Proposal Request

PROJECT: *(name and address)*
AWSOM
Bentonville, Arkansas

PROPOSAL REQUEST 039

MSE Walls, Curbs, and Grading

2 MSE WALL GUARDRAIL - TYP. SECTION DETAIL
1 1/2" = 1'-0"

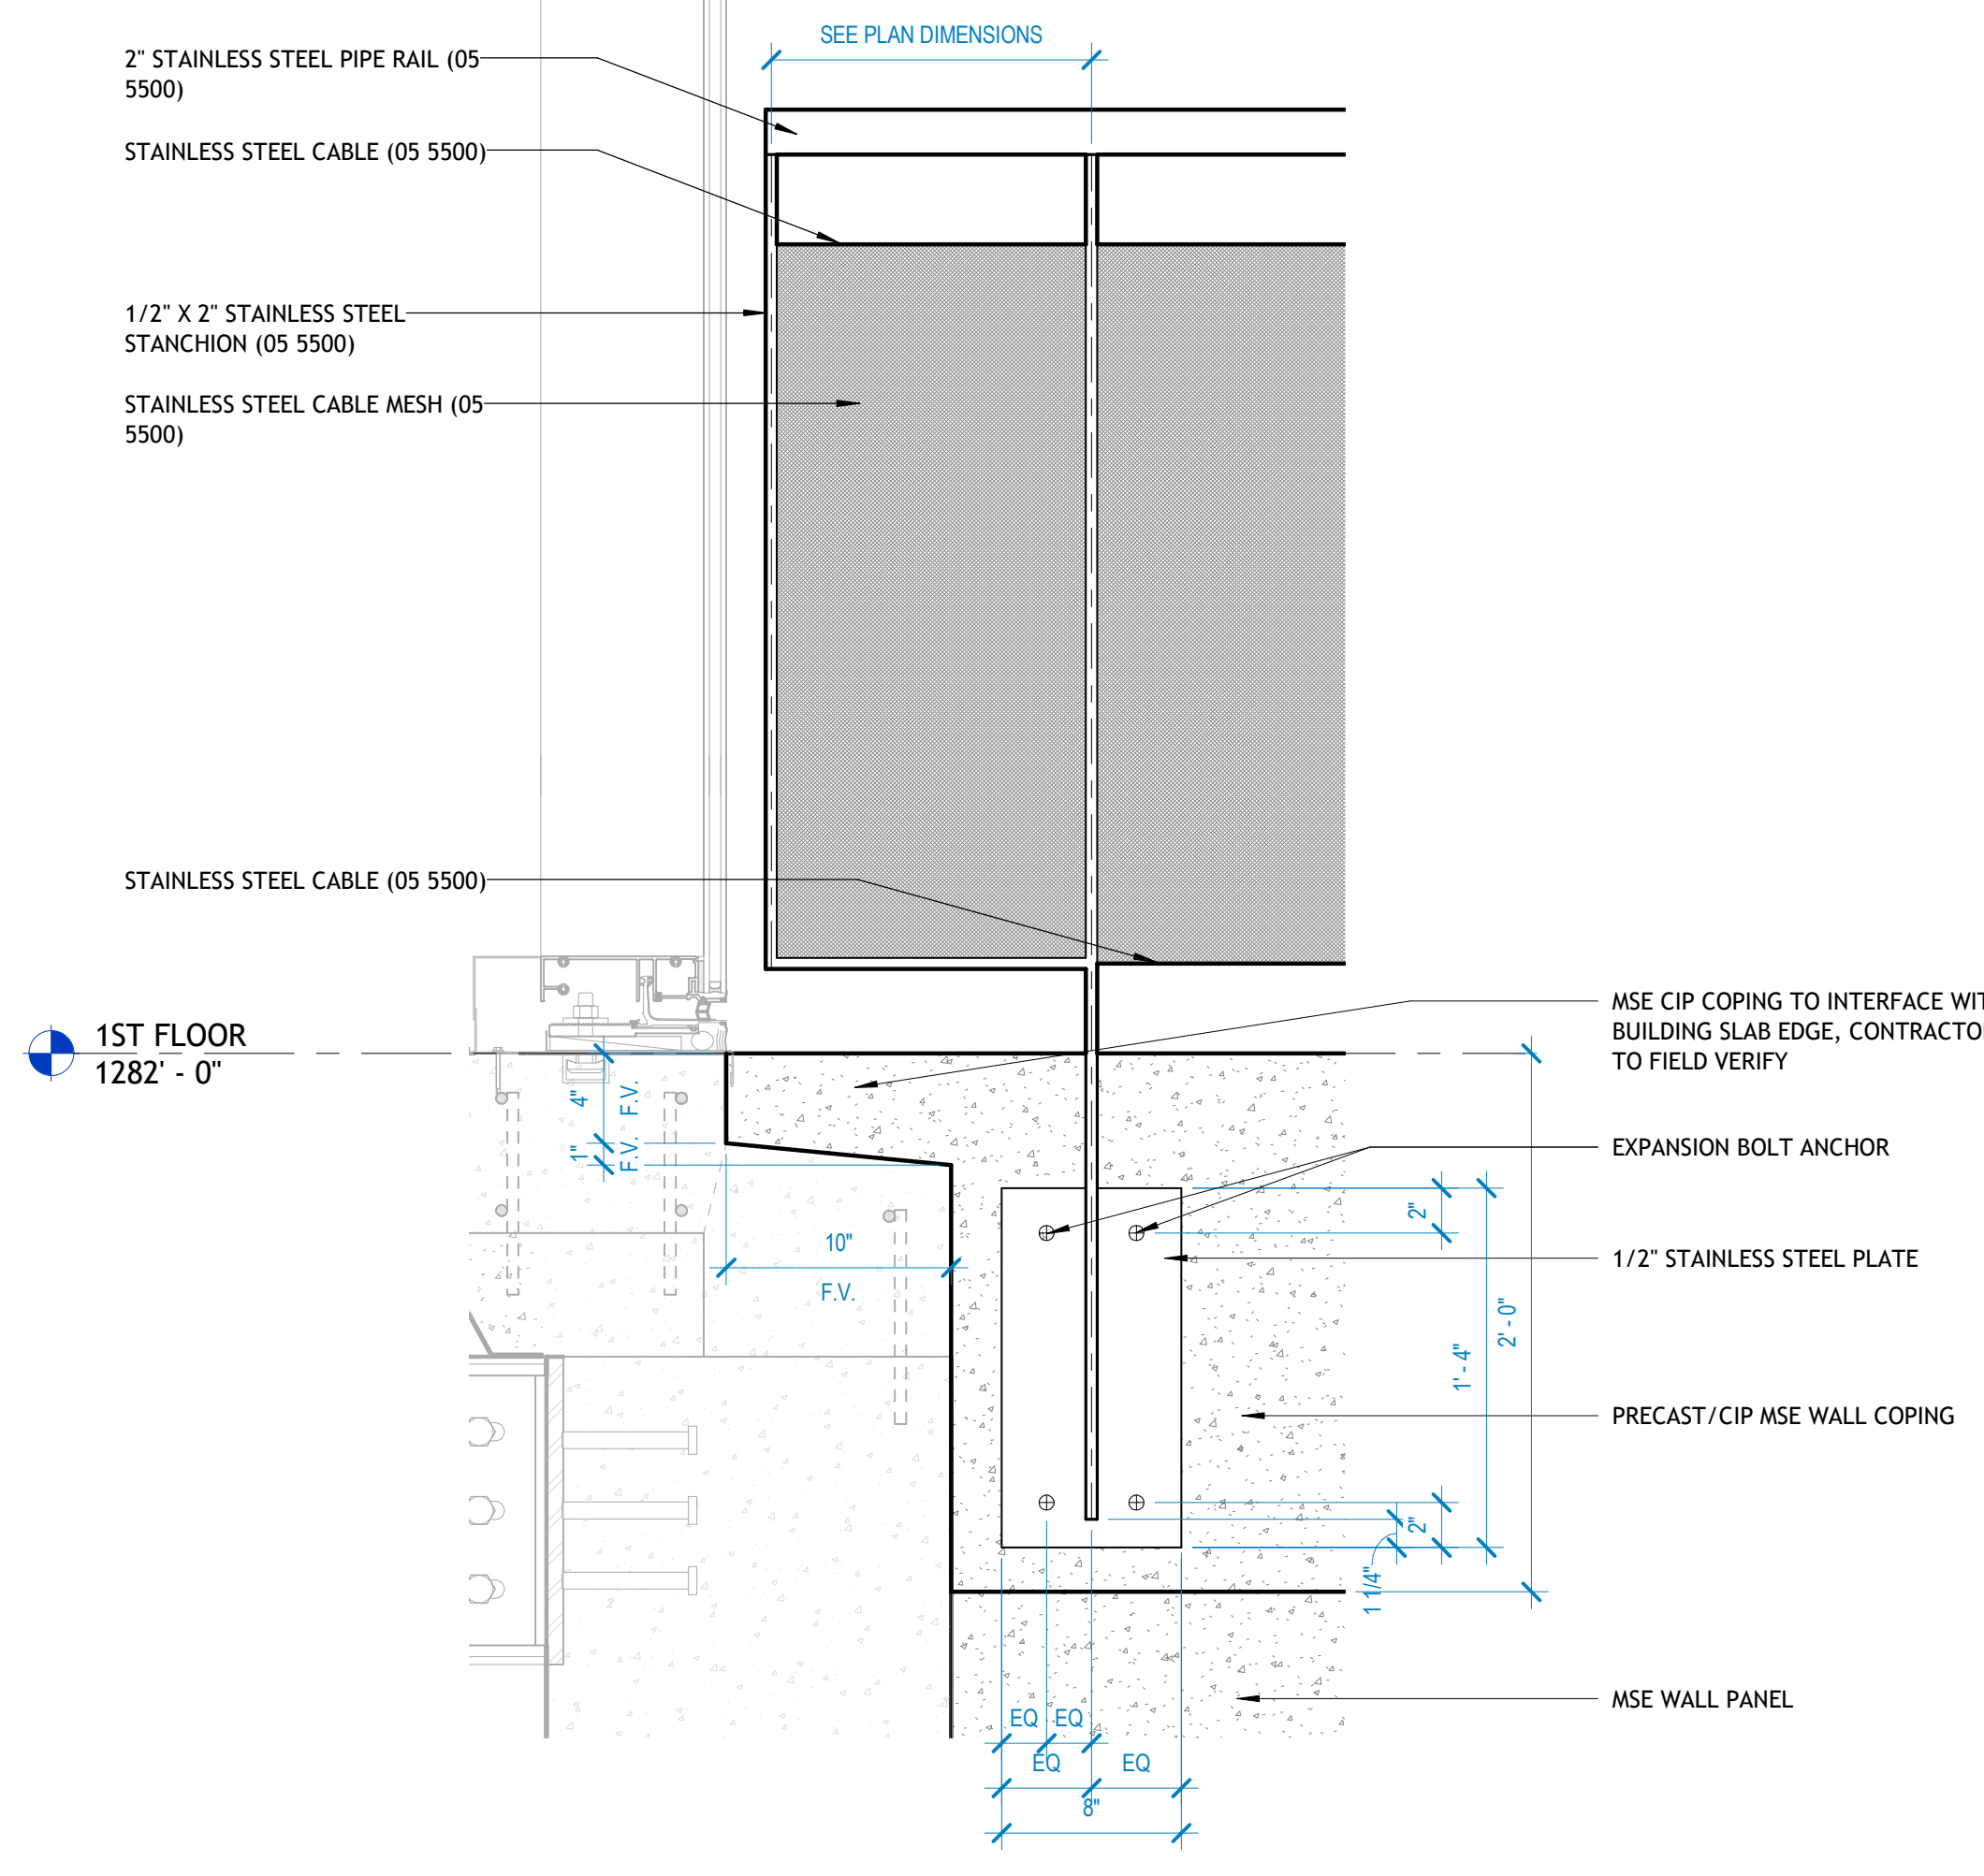
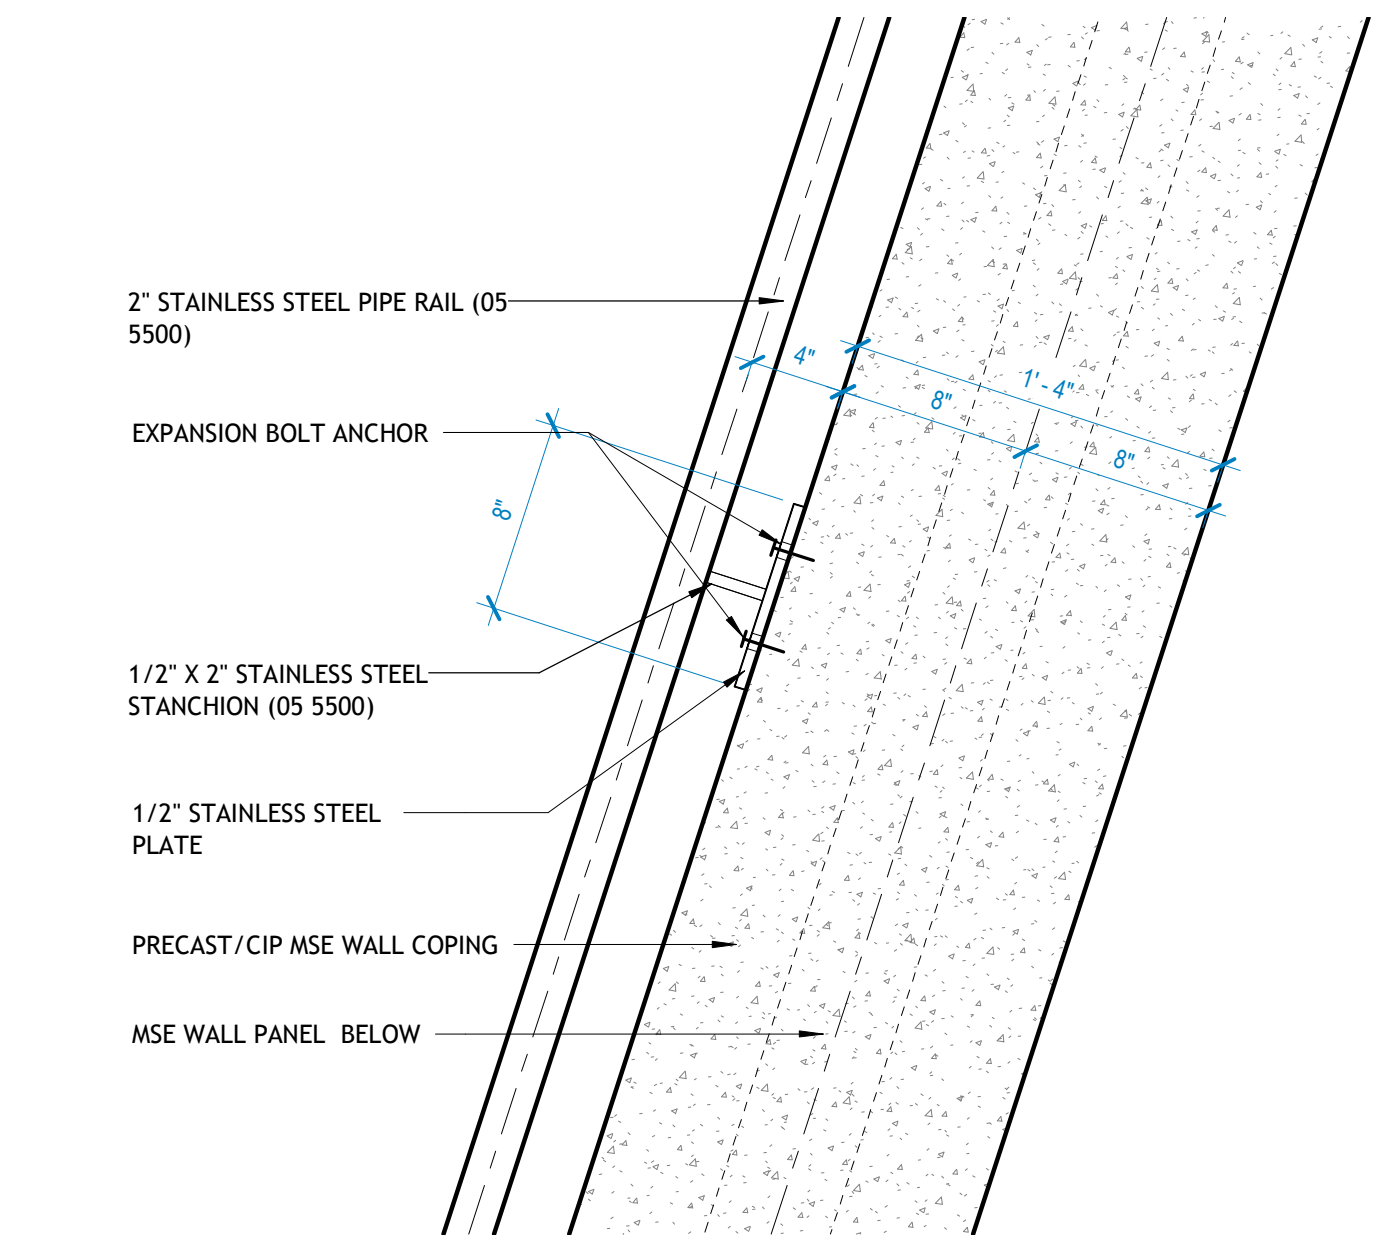
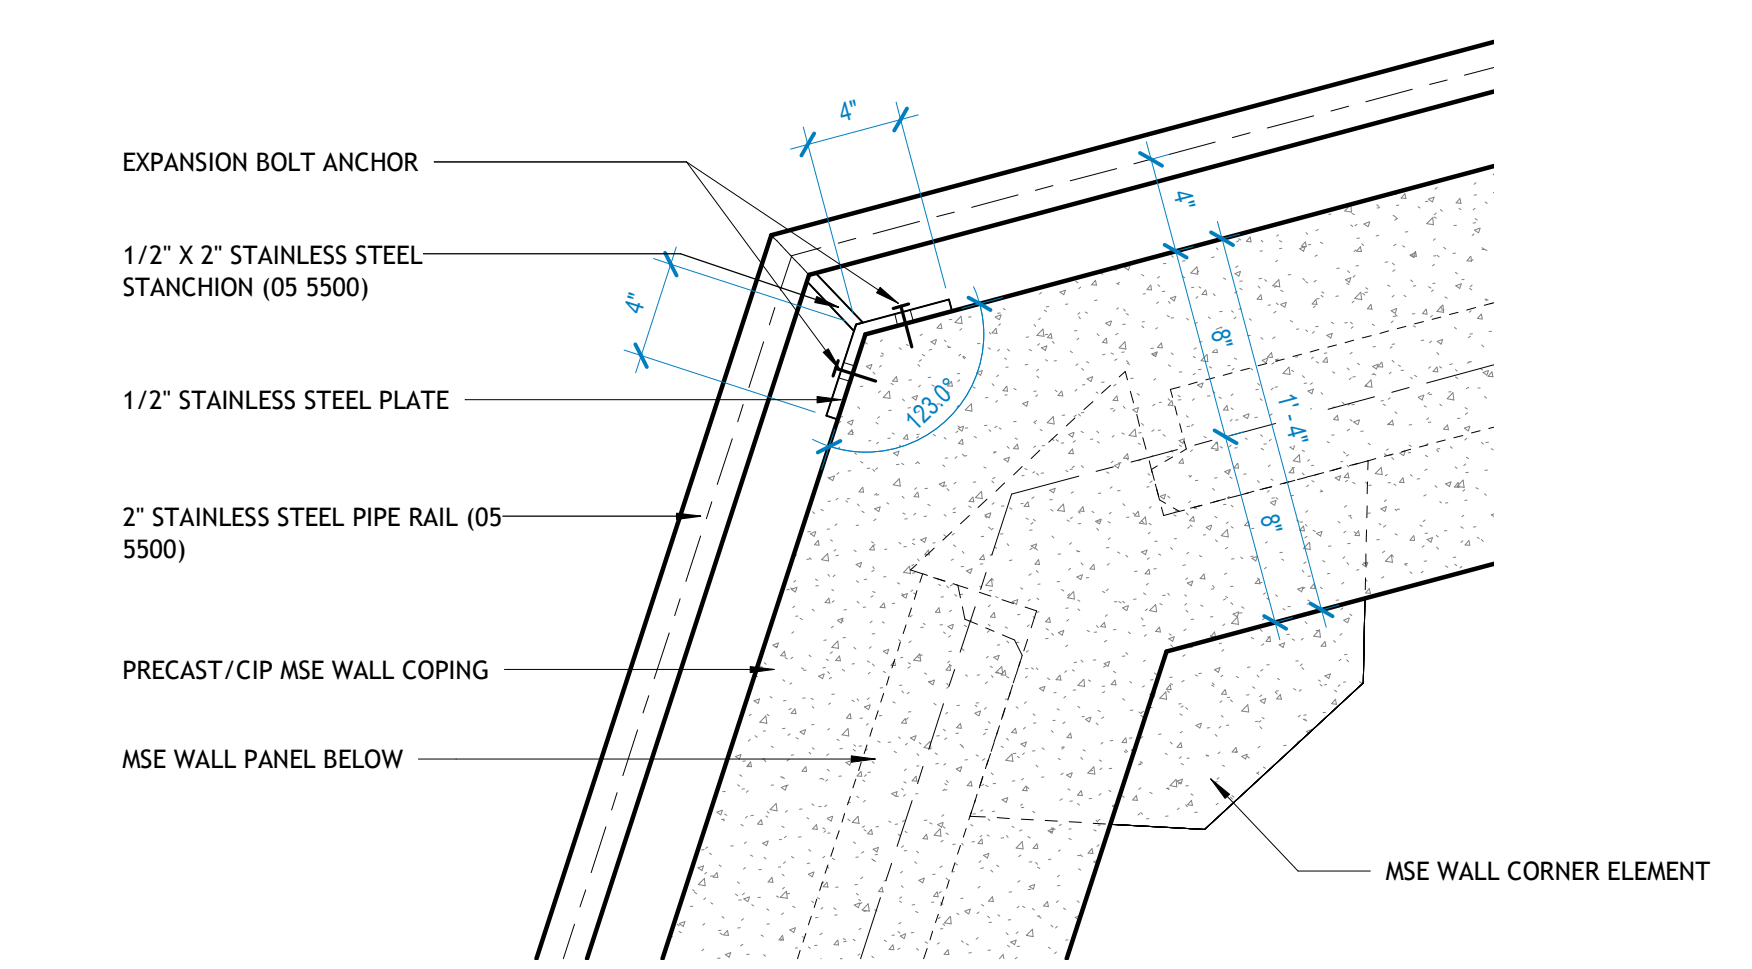
- a) Refer to Revised Sheet **A100AD**, with original issue date 02.24.2023 and revised date 04.04.2024.
 - Dimensions on MSE wall revised.
- b) Refer to Revised Sheet **A100BD**, with original issue date 02.24.2023 and revised date 04.04.2024.
 - Dimensions on MSE wall added.
 - Note on landscaping curb added.
- c) Refer to Revised Sheet **A101A**, with original issue date 02.24.2023 and revised date 04.04.2024.
 - Notes on MSE walls omitted.
- d) Refer to Revised Sheet **A101B**, with original issue date 02.24.2023 and revised date 04.04.2024.
 - Notes on MSE walls omitted.
- e) Refer to New Sheet **A607**, with original issue date 04.04.2024.
 - New MSE wall layout added.
 - New guardrail details added.
